A.M. Wright
12 Parkes Lane
Terranora NSW 2486

29th March 2011

**Re: The development of Altitude Aspire- Project No 090166—Fraser Drive
Terranora N.S.W.**

Fig 1. Retaining Wall Failure Bulwarra Place, Bilambil Heights

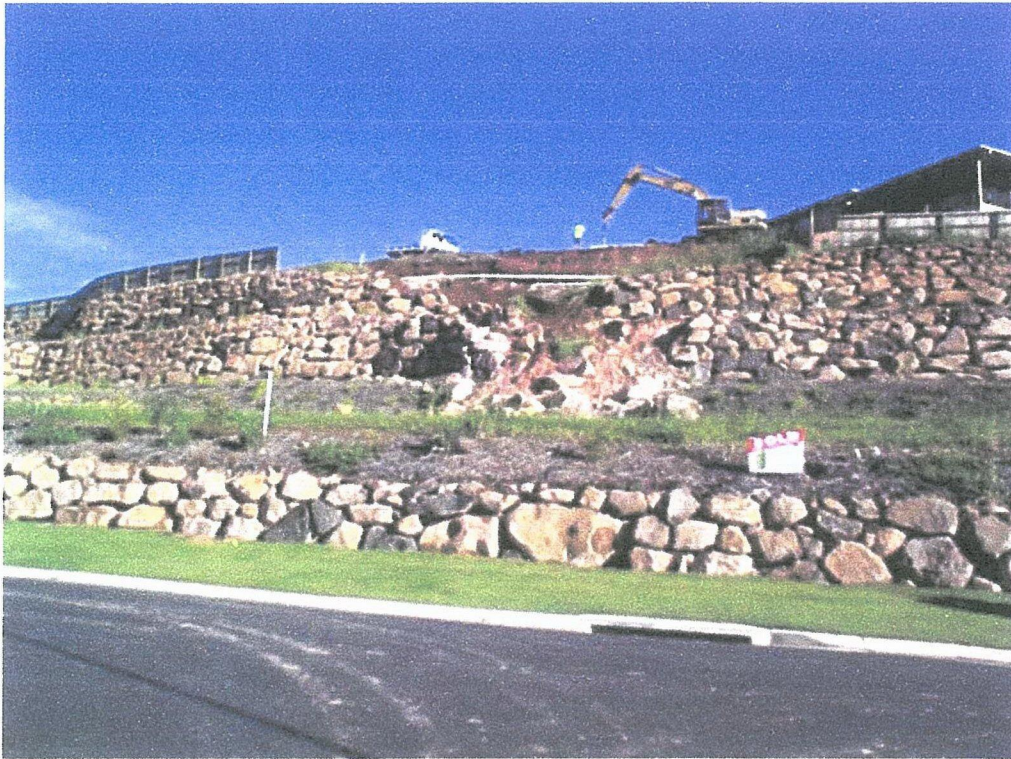
- Tweed Shire Council regulations stipulate 1.0 cut with 1.0m (As at 1/03/2011) fill to prevent a development like Bancrana Ave, Banora Point or the collapse of retaining walls as in Bulwarra Place Bilambil Heights. See attached photos 4/5

- There was a significant retaining wall failure in a recent subdivision (Bulwarra Place).
- Long term stability of high retaining walls and cuttings is often dependent on effective drainage systems. Drain maintenance and repair are difficult to guarantee in subdivisions, particularly where multiple ownership interallotment drainage systems are used.

AREA - ANTITUDE ASPIRE
FLOODING TAKEN FROM
PARKES LAKE

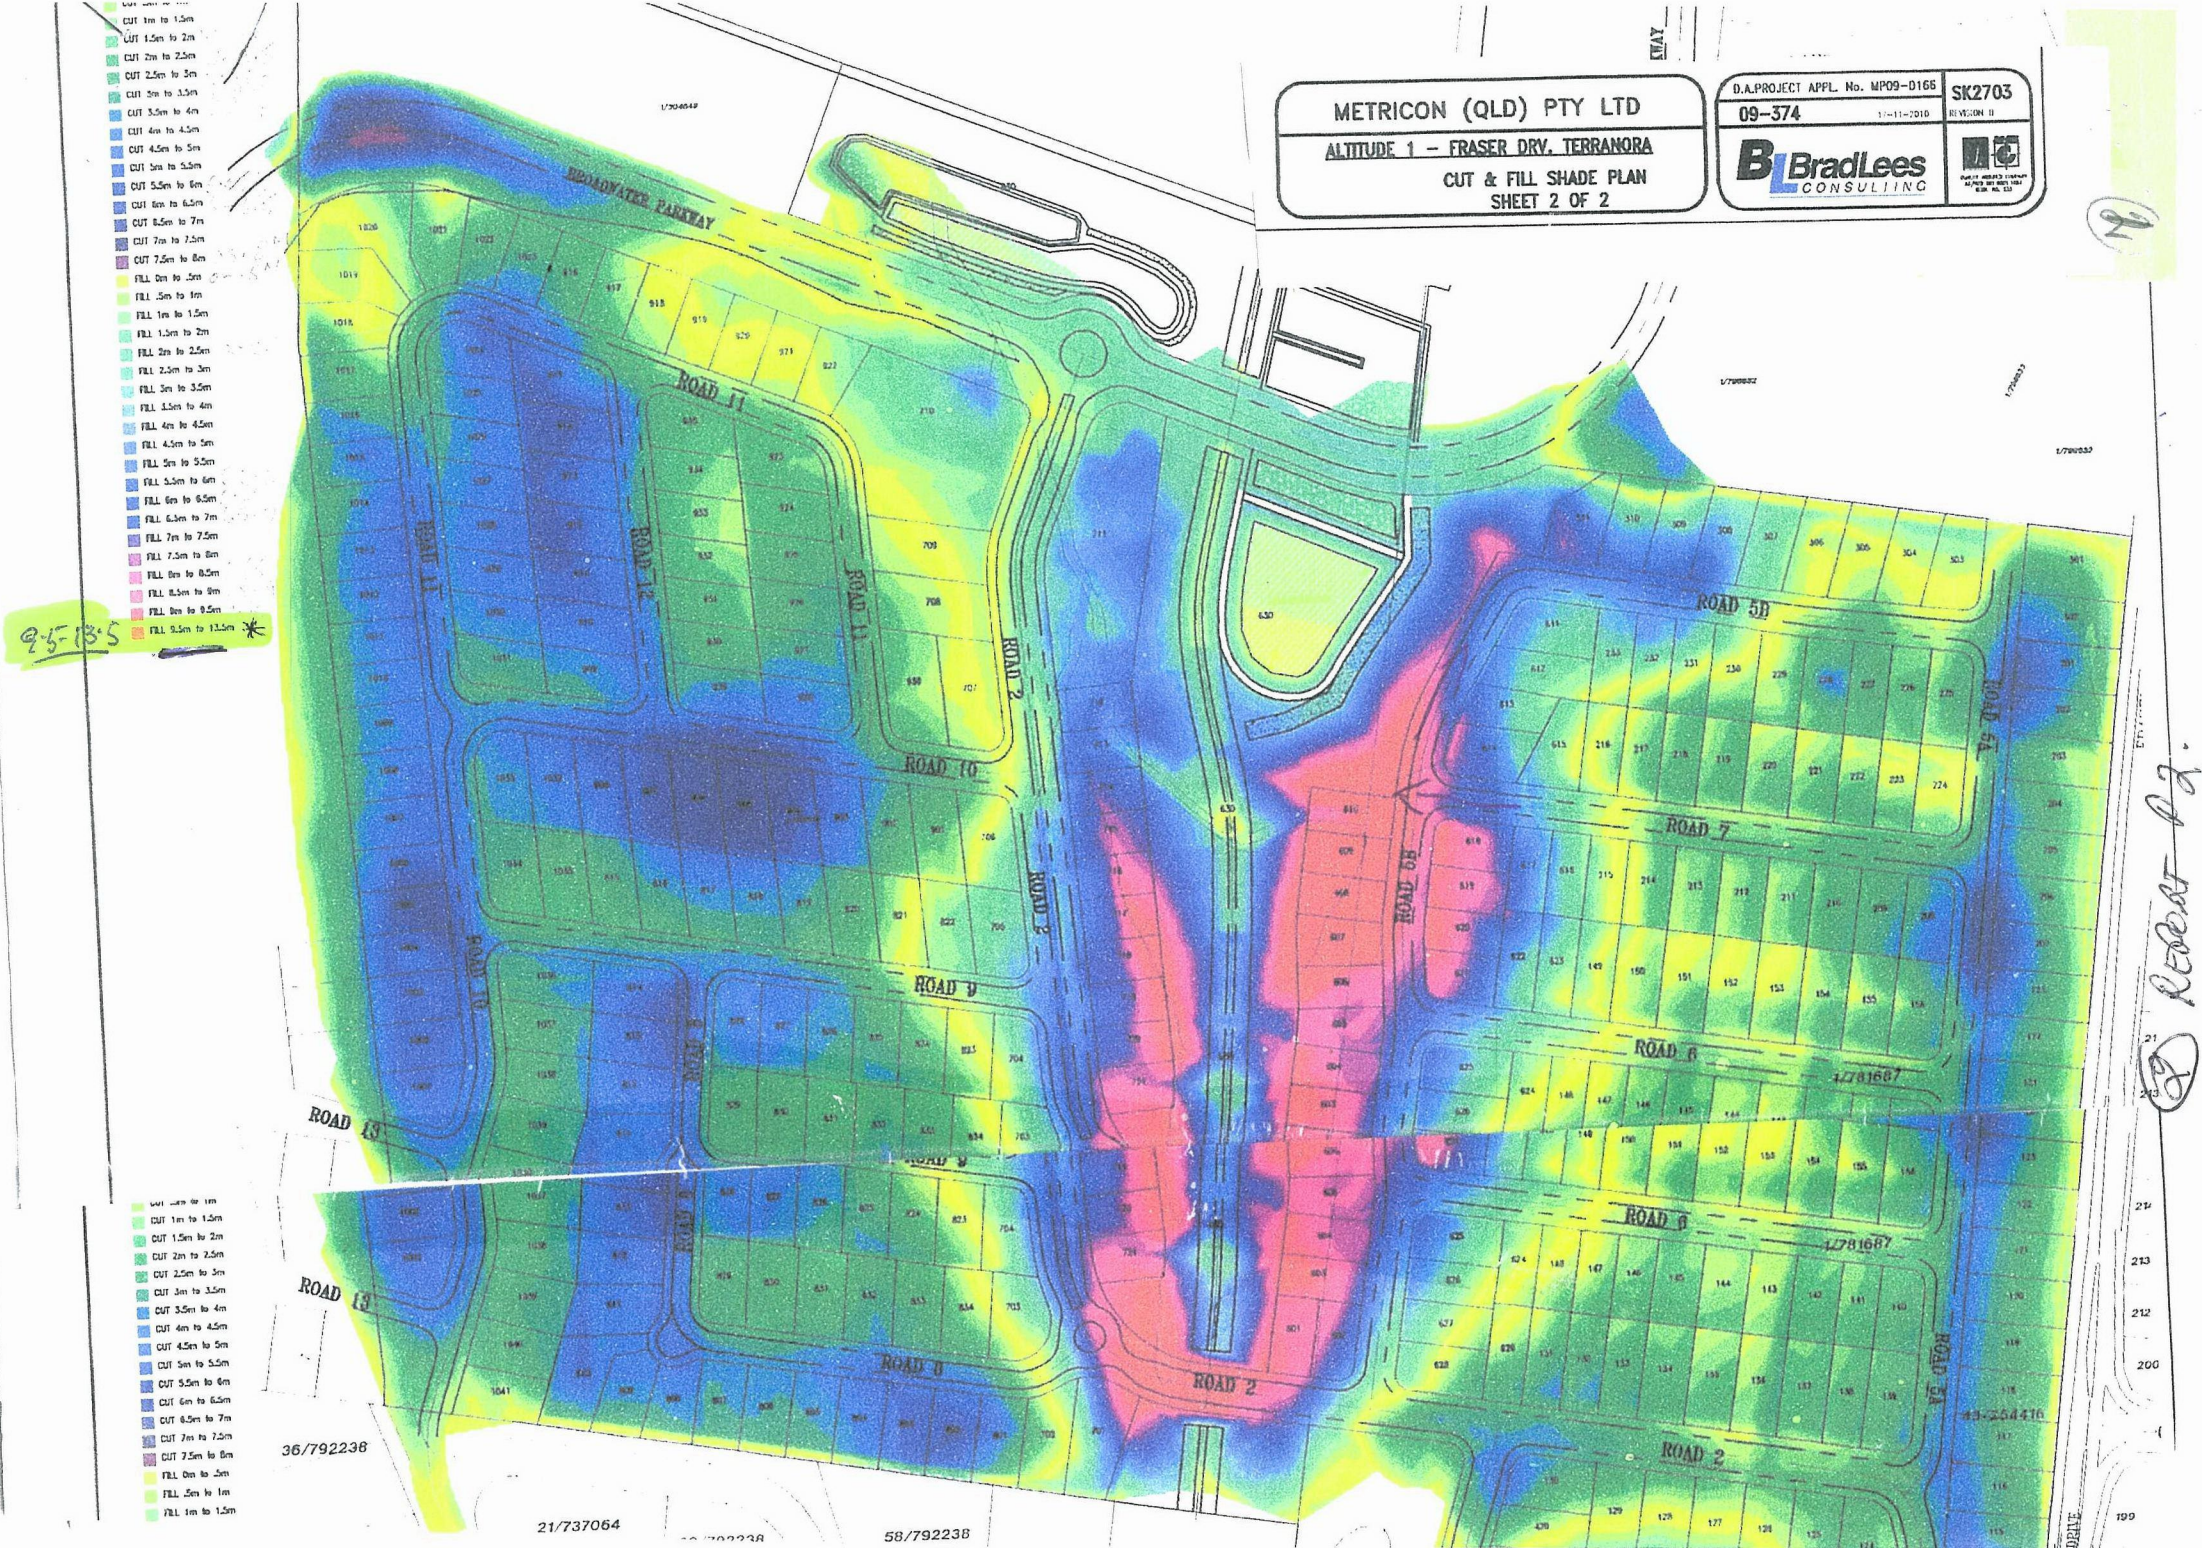
My submissions stated that a major development with small lots of 450 sq. metres would destroy and impact on one of the most beautiful areas of the state. In pursuing this objective there would need to be massive earthworks of cut and fill to the steeper escarpments to raise the lower levels, which have huge flooding and drainage problems. The area below Parkes Lane is a catchment for storm water and is always flooded in heavy rains with the added problems of acid sulphate soils. (See attachment 1 — Photos of flooding)

SLOPE ANALYSIS

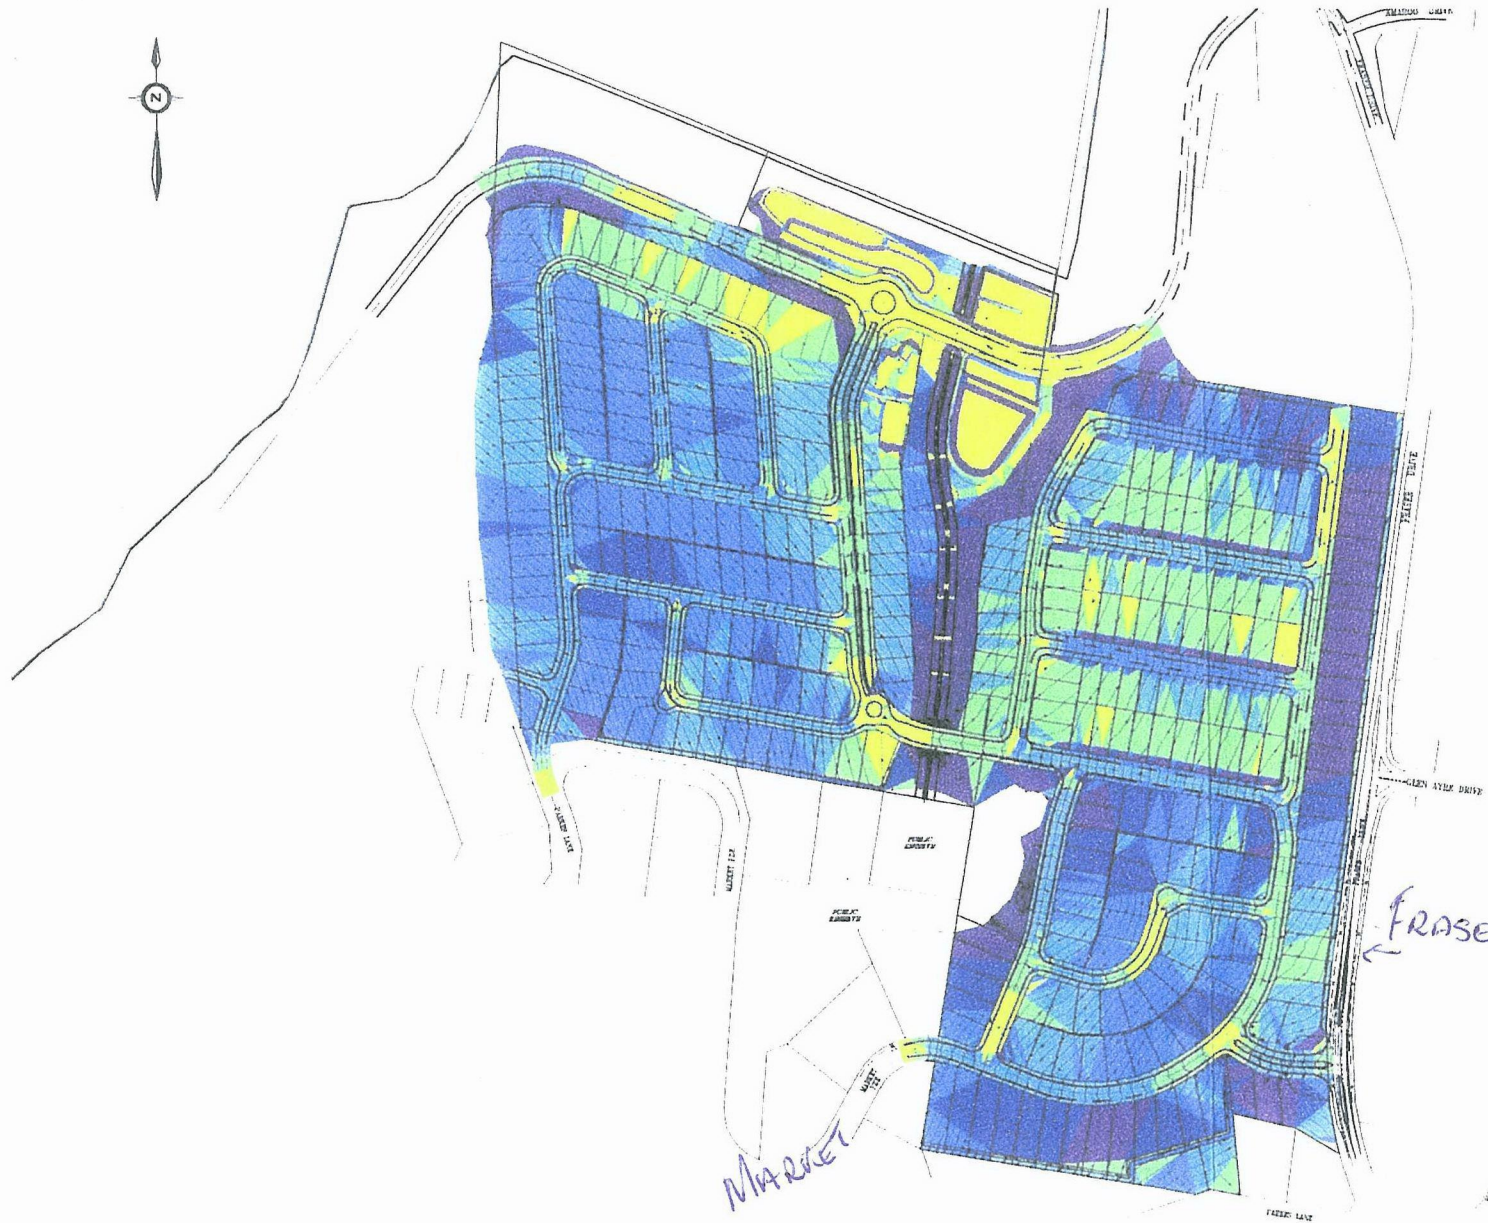
- As a consequence of the existing topography, and the proposed earthworks, it is expected that approximately 18 % of the site will require earthworks greater than 5.0m depth. Centrally the development will require cut and full up to 13.5 m over the natural water course and movement of material across the whole of area E. Some slope sections are greater than 25%. (Ref Bradlees Consulting Cut and fill – Legends section 5 and Slope Analysis 17/11/2010 See attachment 2/3)

ALTITUDE 1 - FRASER DRV. TERRANORA
BUILDING PAD LAYOUT & SECTIONS.
Sheet 2 of 3

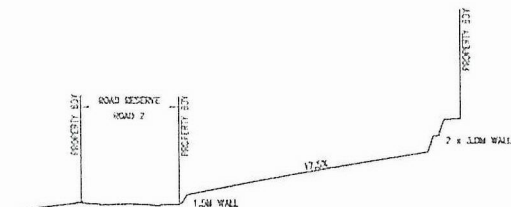
- Are they the 3m retaining walls, above or below ground? I see no public reserves abutting Parkes Lane. However there will be 2x3m (total 6m) walls on the southern boundary plus a 1.5m retaining wall to the sub division road 2 (total 7.5m) and two narrow allotments abutting my home .How can roads and these walls be called buffers??? (See Attachment No.6&7 SK2759 Bradlees Building Pad Layouts sheet 2of3)
